**McLean's Mountain Wind Farm**

**Re: McLean's Mountain Wind Farm Project  
Renewable Energy Approval (REA) - Amendment**

*Modifications Document for  
REA Amendment - March 2013*

### McLean's Mountain Wind Farm Figure 2: February 2013 Revised Project Layout

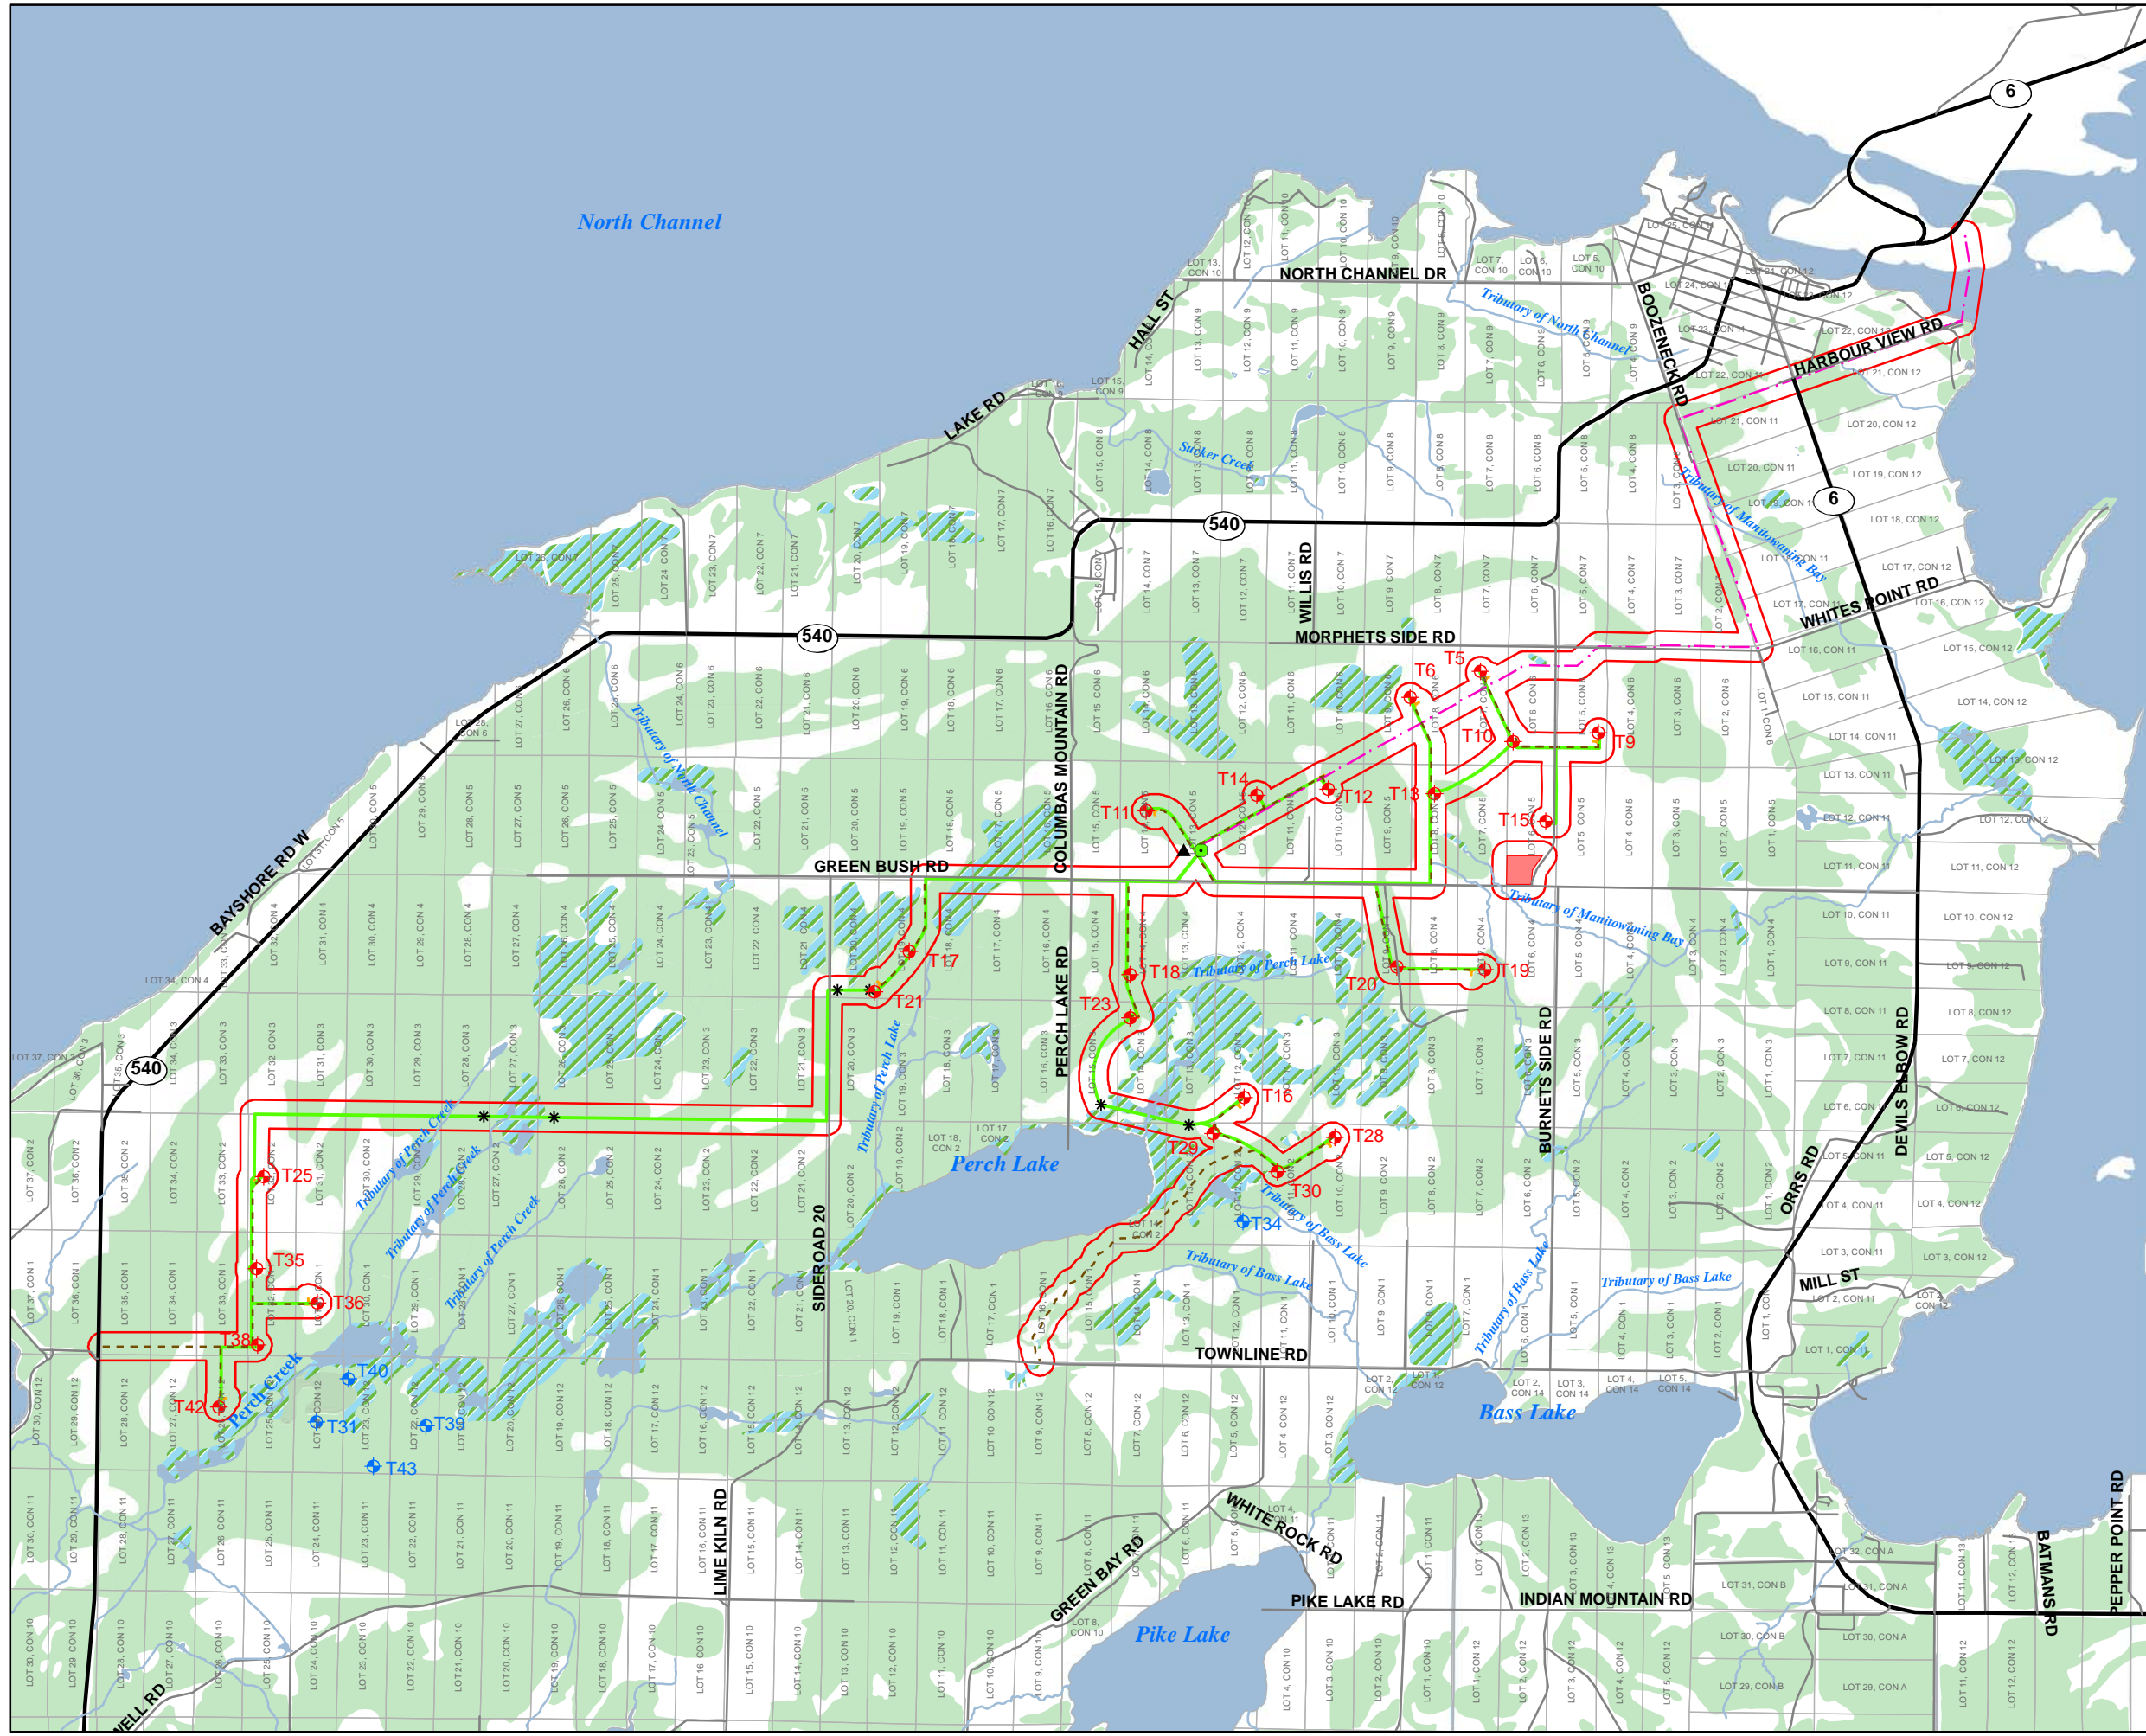
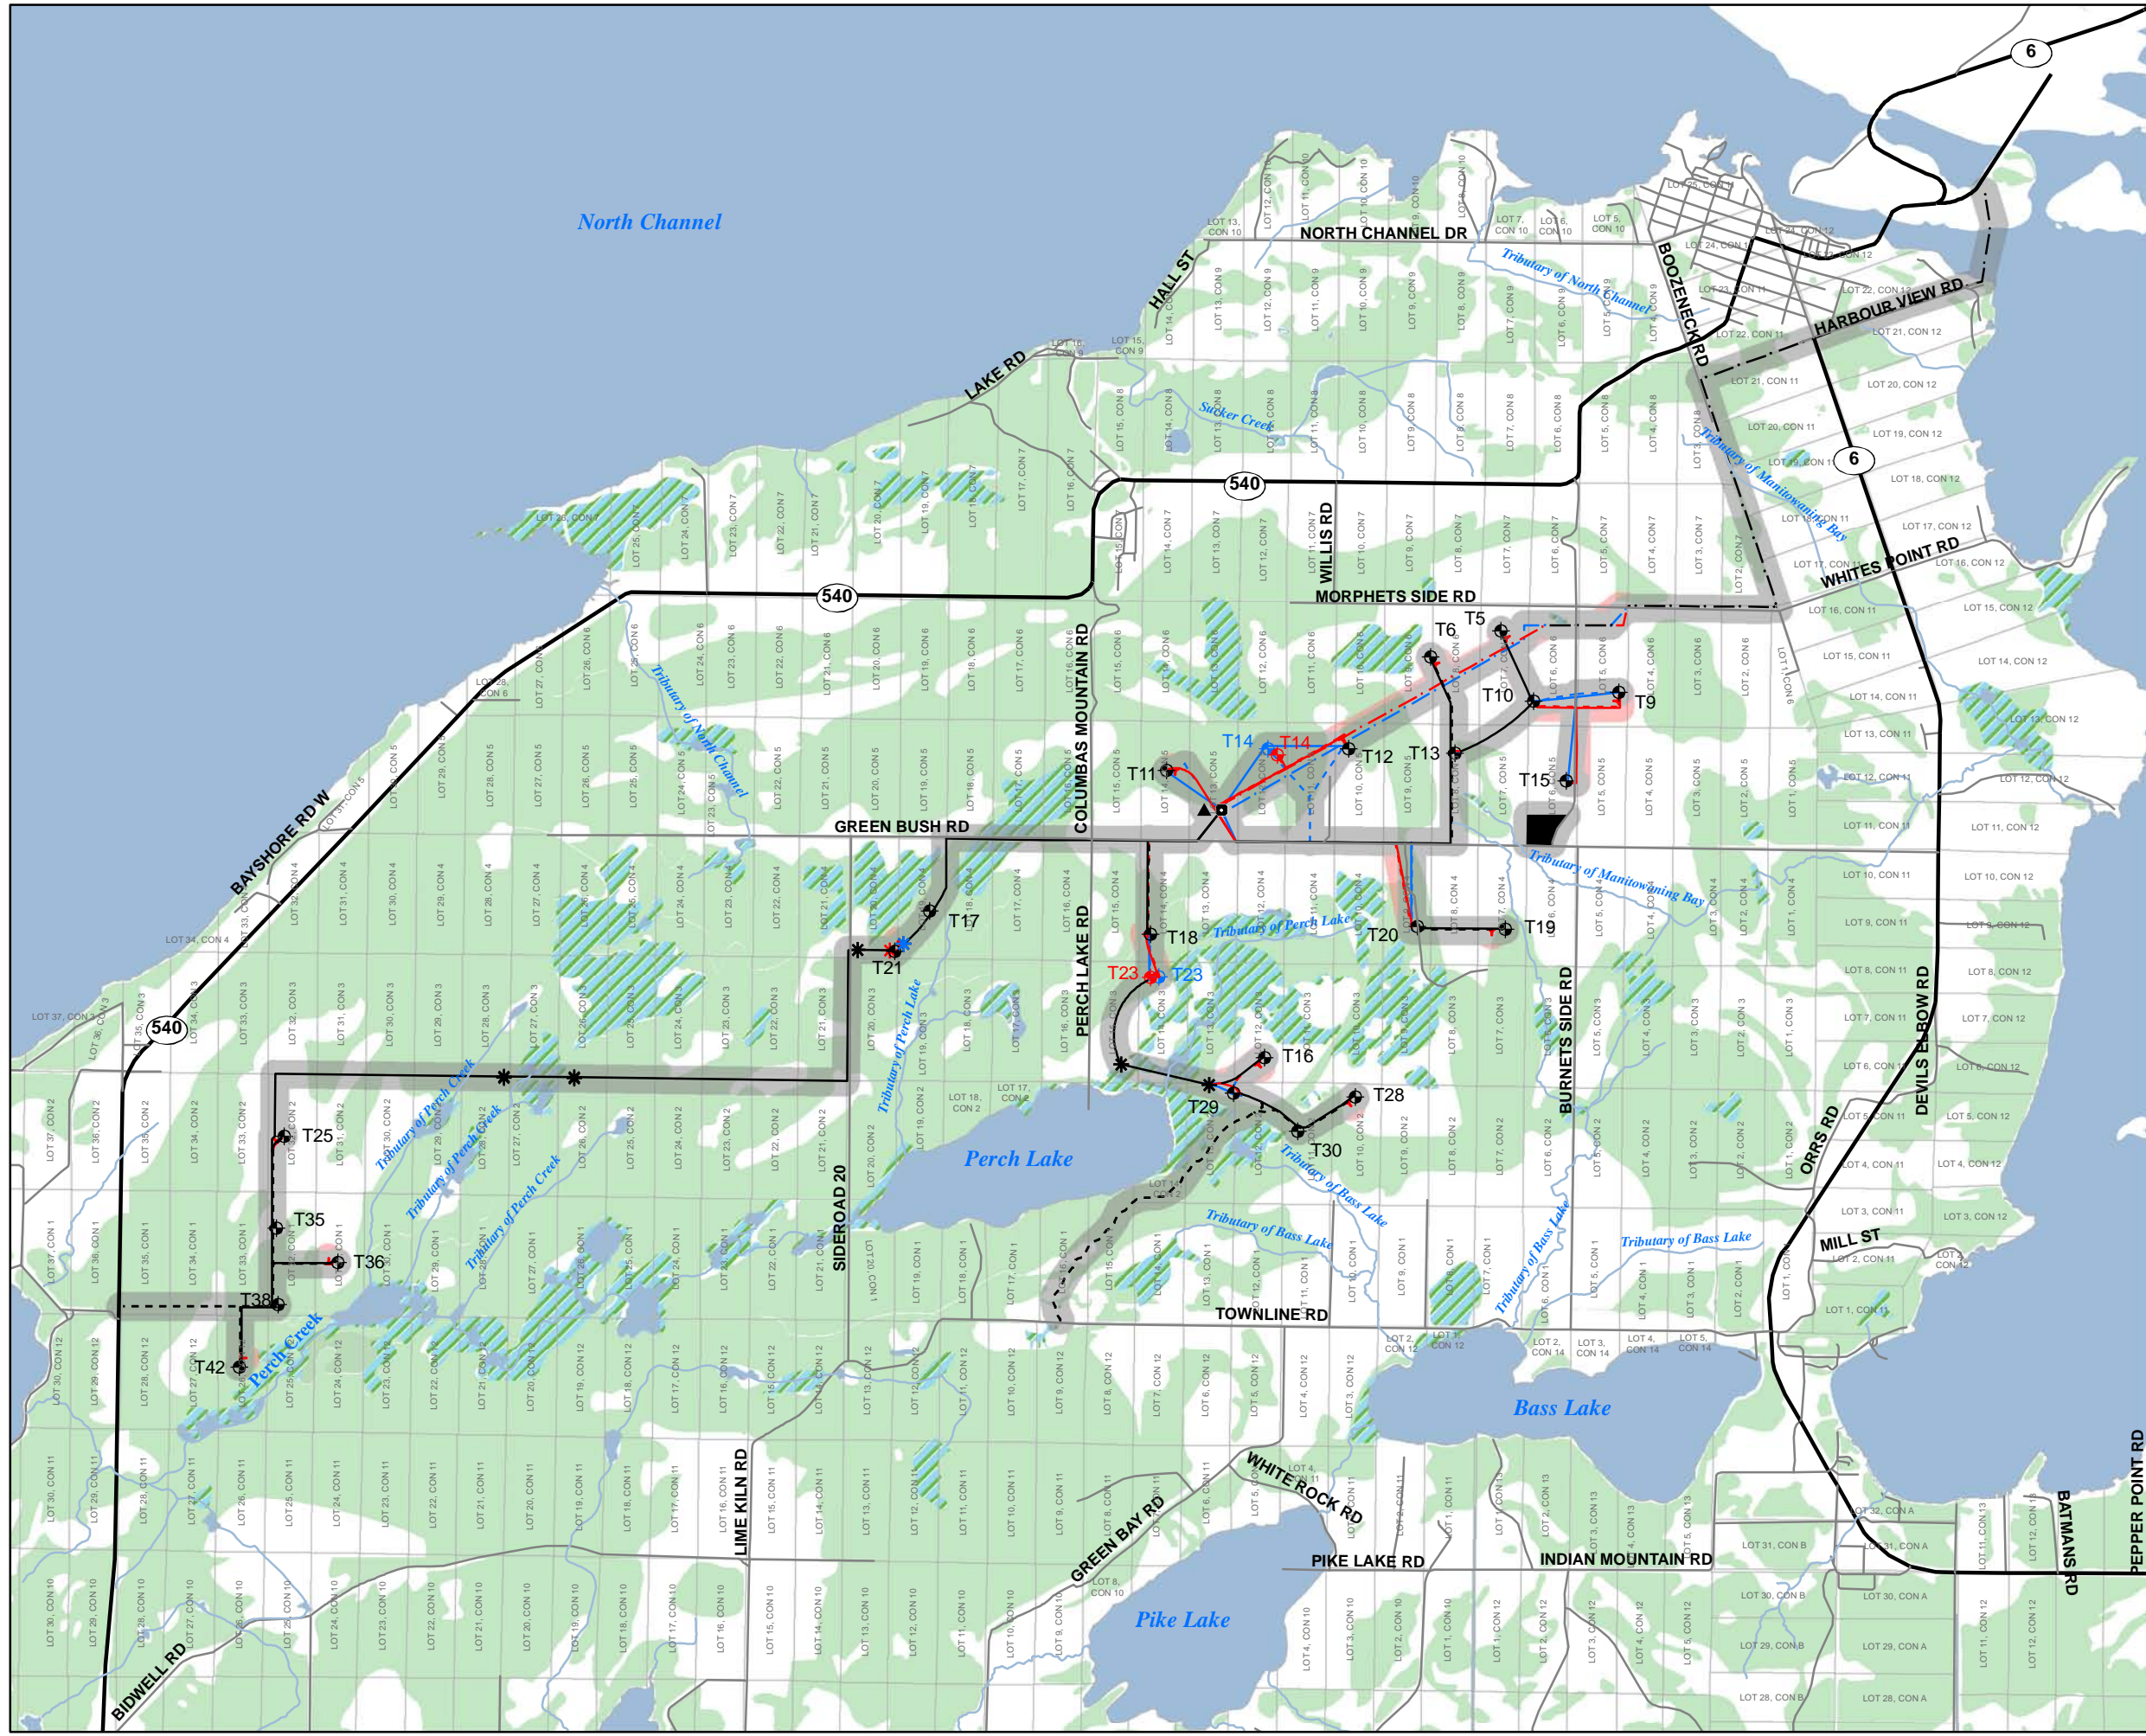
Component	Location of Original & Revised Components	Proposed Change	Rationale
Turbine T14	Lot 12, Con 5	Shift south-east by 100 metres within the same property parcel.	It was determined following detailed geotechnical evaluation that the topography/geology made the original location unfeasible. The new position of the turbine will be located on lands previously assessed for the access road /collector line. The relocation will result in a decrease in tree cutting and land clearing.
Turbine T23 and related access road and feeder line	Lot 14, Con 3 (turbine) and Lot 14, Con 3 and Lot 14, Con 4 (access road and feeder line)	T23 to be moved west of currently location by 80 metres within the same property parcel. Access road and feeder line to T23 to be angled slightly east of current path between T18 and T23.	Shift in location made to increase the distance between the turbine site and an adjacent wetland and to reduce the length of the access road and feeder line to the site. The new position of the turbine will be located on lands previously assessed for their access road /collector line. The relocation will result in a decrease in tree cutting and land clearing.

metres, tapering to 0 metres on the eastern side.	the transmission line from the substation would be from the north west corner of the substation. As a result, a small shift of the transmission line alignment to the north is required. The shift also optimizes the distance of the transmission line from turbines that the line passes by.
HDD Staging Area near T21	Lot 19, Con 4 (original) Lot 20, Con 4 (revised)	Shift southwest by 129m metres of staging area for directional drilling, placing it on west side of turbine	Better location of HDD staging area due to: a) topography for the set-up of the drill rig, and; b) avoiding potential drilling interference with the T21 foundation.
Access road and feeder line to T9 from McLean's Mountain Road	Lot 5, Con 6	Shift to the south by approximately 100 metres with north turn to turbine.	Shift requested by landowner to maximize distance from a water spring used by livestock.

T20 and Green Bush Road		west.	turbine sites with construction equipment.
Shift of feeder line to the northeast between T29 and HDD located to the northwest.	Lot 13, Con 2	Shift northeast by approximately 56 metres	Refined during detailed design – shifted to avoid wet areas to the south and to swing wide of the turbine's crane pad.
Access roads between T14, T12 and Green Bush Road	Lots 10-13, Con 5	Elimination of originally-planned access roads and adjustment of the feeder lines from T12/T14 and the proposed project substation. Access Road connecting T12 and T14 to come directly from substation and more closely follow transmission line path. Access road off of Green Bush Road, including "Y" junction, to be removed.	In conjunction with the relocation of turbine T14, it is proposed to relocate the access roads and electrical collector lines connecting to turbines T14 and T12. The original plan for the access road was to cut a single-purpose path through forest to create the access routes. The original plan also required that a separate swath of trees be cut for an independent electrical collector line route. This proposal would merge the access roads and collector line routes and run them immediately adjacent to the main 115 kV transmission line route. This adjustment will greatly minimize the amount of forest that needs to be cleared.

Hammerheads	Throughout project location along access roads.	Addition of thirteen (13) hammerheads to the mapping provided	It was always intended that truck turnaround areas would be required adjacent to the access roads, but until detailed design was completed the location of these turnaround areas (or hammerheads) was unknown. The project location figure now identifies the proposed location of the hammerheads, most of which are in areas that do not require vegetation removal or habitat disturbance.

The original site plan submitted with the REA application is provided in *Appendix A*. The revised site plan, based on the changes discussed above, is provided in *Appendix B*. To easily compare the final site plan and changes with the original, *Appendix C* provides a site plan identifying original components that remain the same, those being relocated and those being removed. While only 24 turbines will be erected, a total of 29 turbine locations were submitted for permitting in the REA application and were approved. *Appendix C* identifies the location of the extra permitted sites.
